RE: **Catalonia Subdivision**
Tr 1 & 2, The Trails Unit 3A
Revised Drainage Report Stamp Date: 3/25/20
Revised Grading Plan Stamp Date: 2/13/20
Hydrology File: C09D013

Based on the submittal received on 3/25/20 the above-referenced Drainage Report and Grading Plan are approved for Plat and Grading Permit. The Work order cannot be approved until the following corrections are made:

RE: **Catalonia Subdivision
Tr 1 & 2, The Trails Unit 3A
Revised Drainage Report Stamp Date: 3/25/20
Revised Grading Plan Stamp Date: 2/13/20
Hydrology File: C09D013**

EXHIBIT E:
STORM DRAIN NETWORK

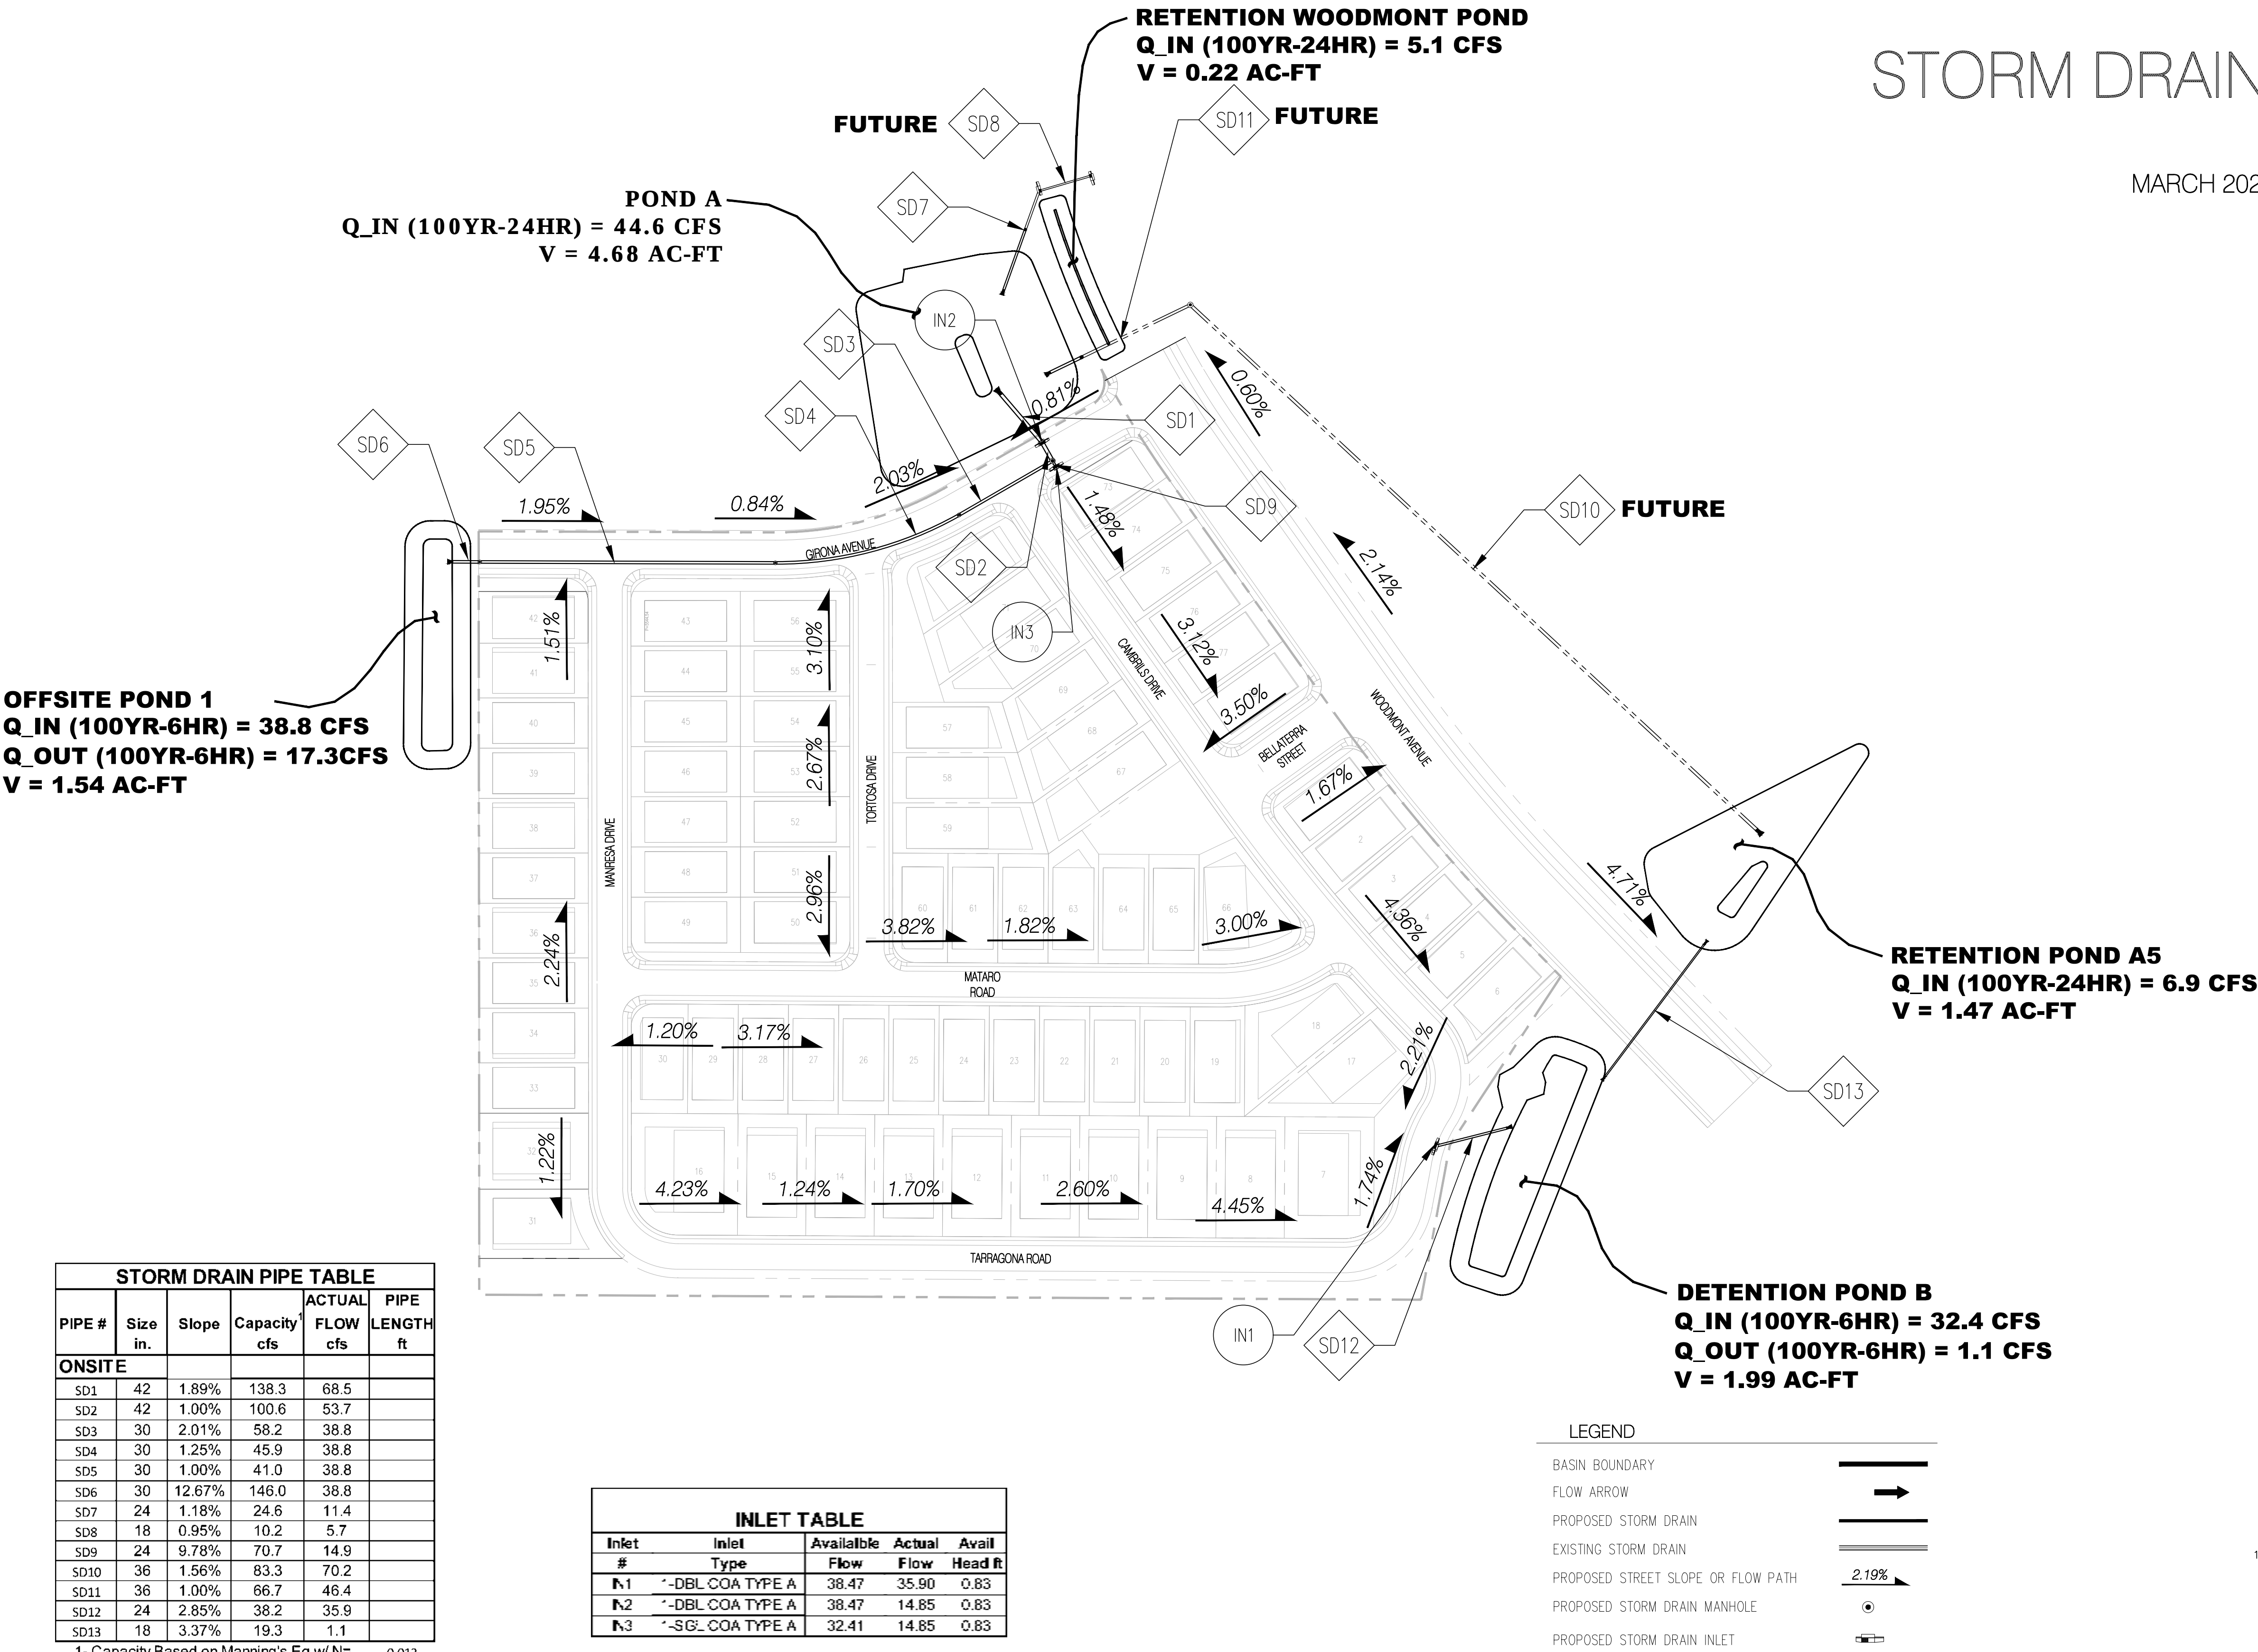
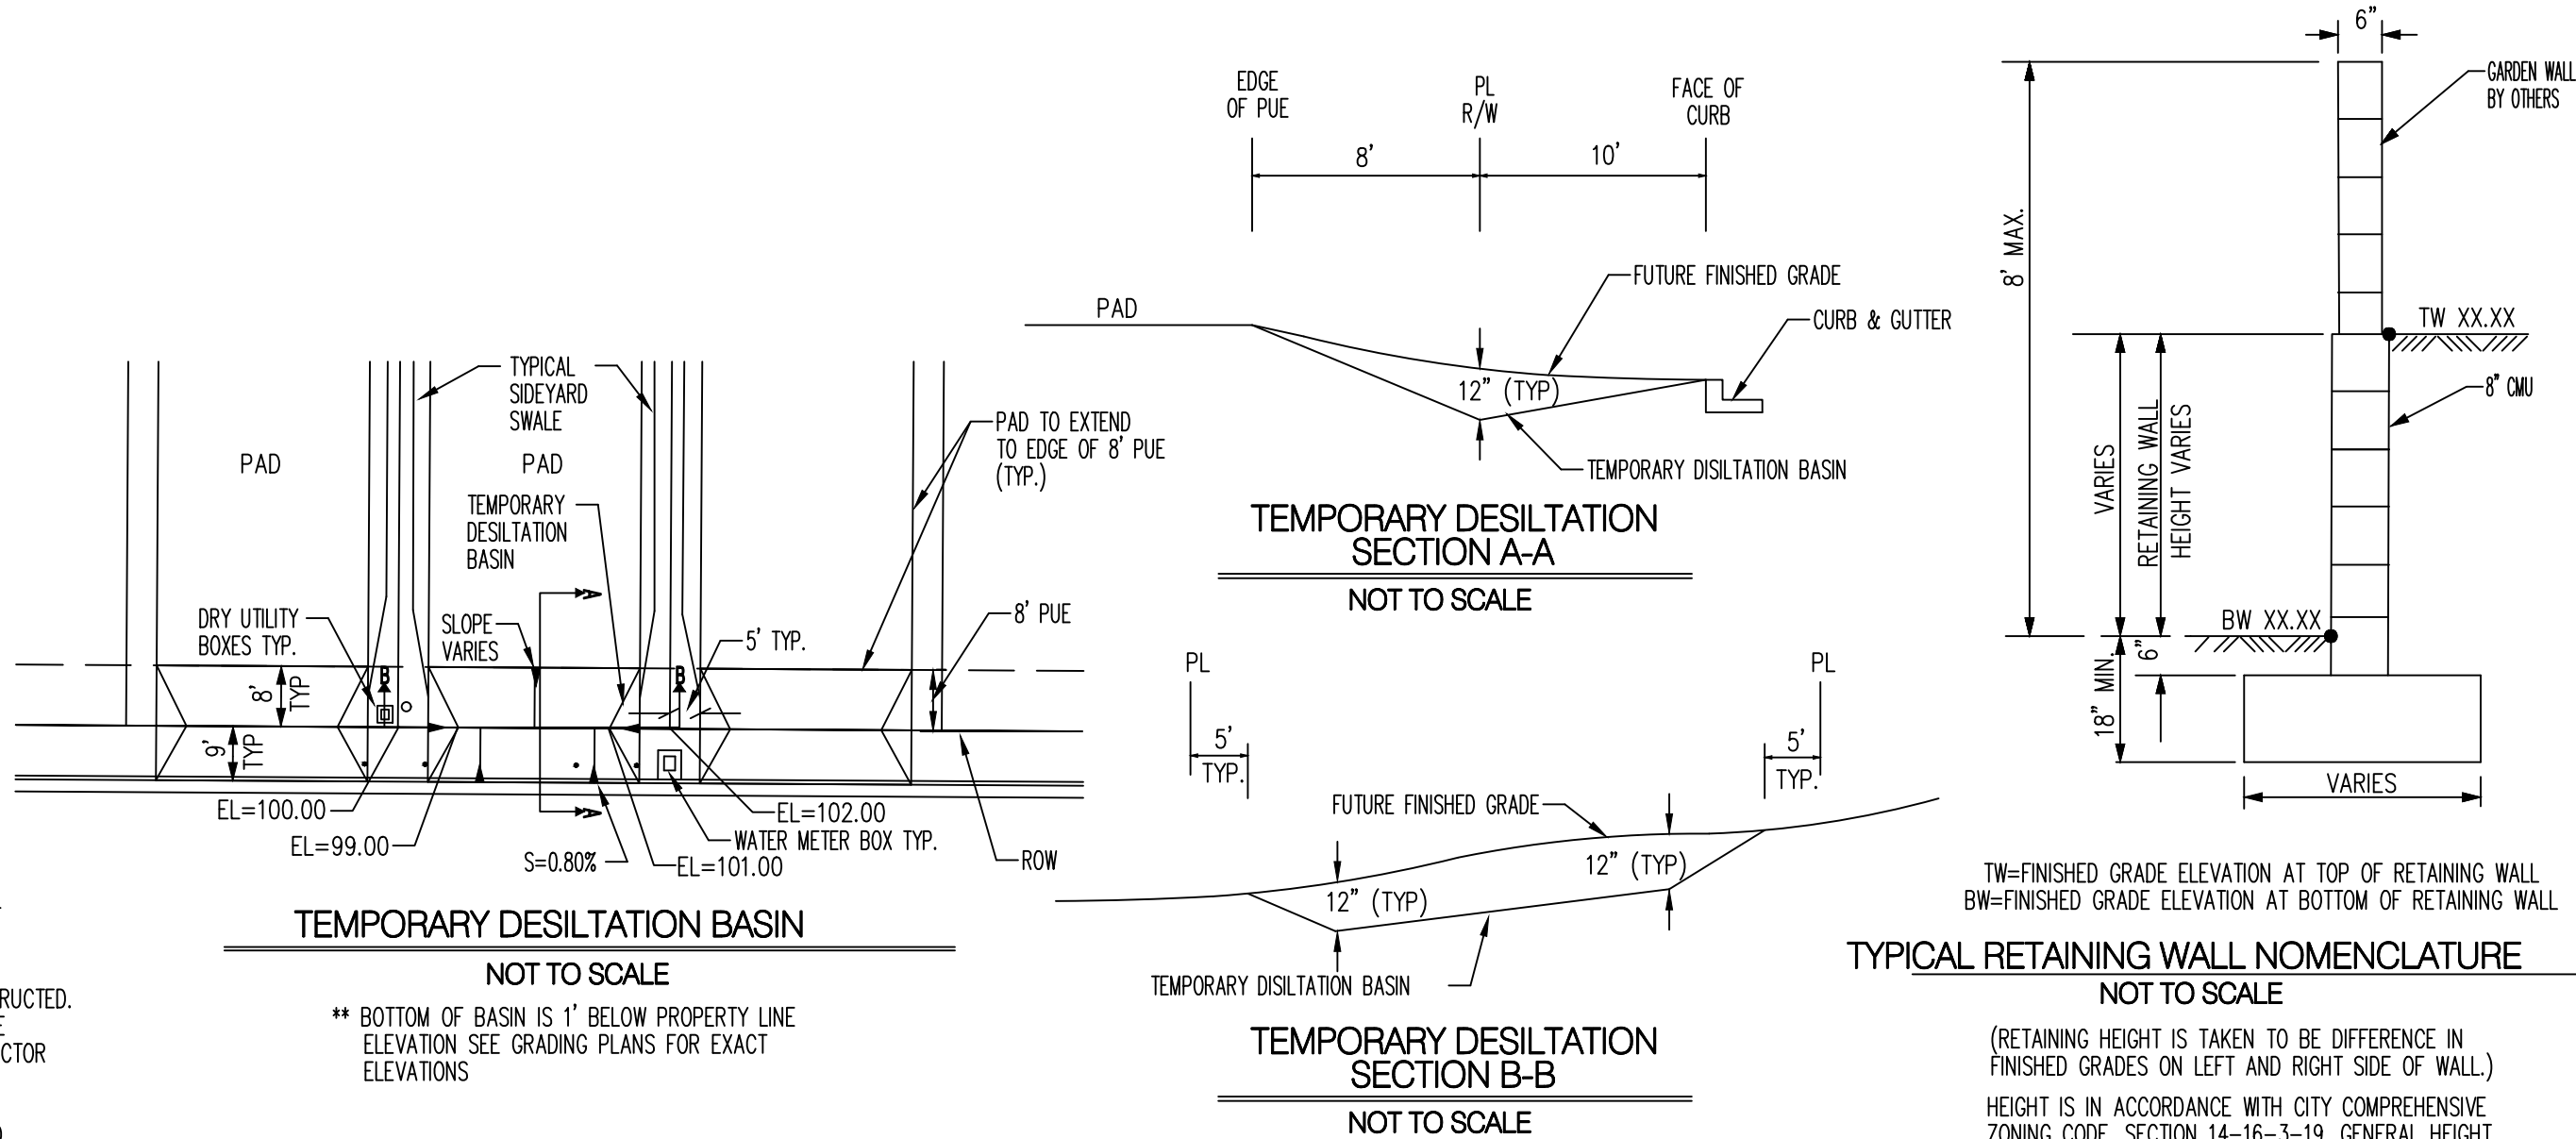
1. The 24 x 36 Storm Drain exhibit needs to be consistent with the Appendices analysis. For instance, IN2&3 are called as Type-C, but are Type-A per the analysis and the storm pipe sizes and flows do not match.

3. IN2 needs to be a double inlet to accommodate the 42" inlet and outlet pipes; otherwise use a manhole and lateral for this junction.

Response: Inlets have been updated to reflect the correct type and the flowrates have been updated accordingly.

Response: Inlet 2 has been updated accordingly

EMERGENCY SPILLWAY
NOT TO SCALE

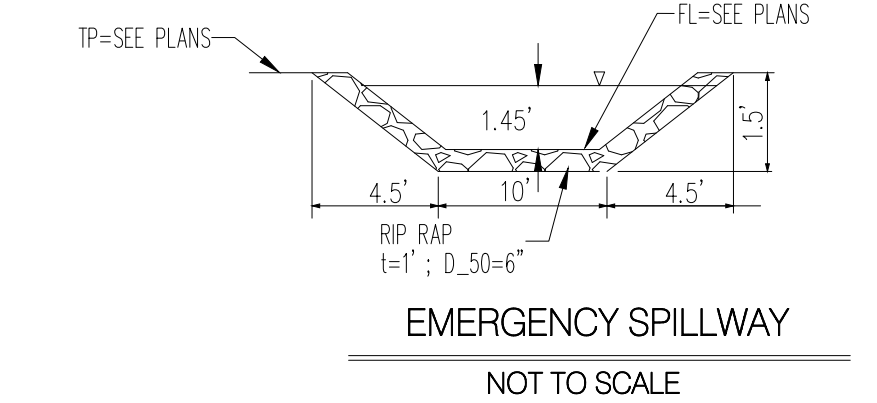
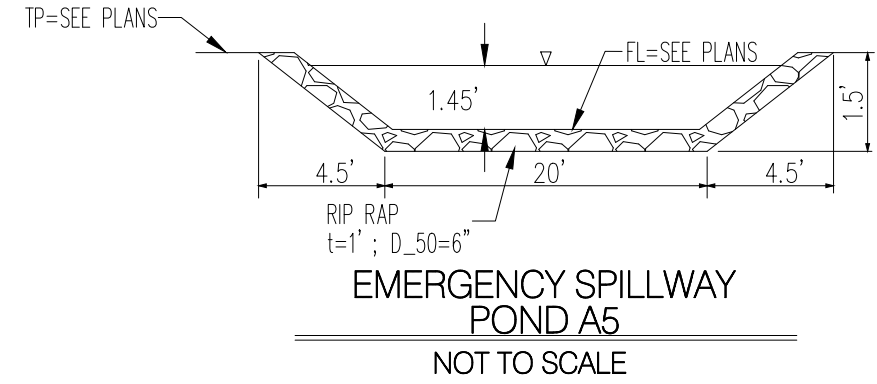
8. Provide dimensional data on the Work Order plans (top width, bottom width, depth, etc.) for the spillways and swale.

Response: Acknowledged.
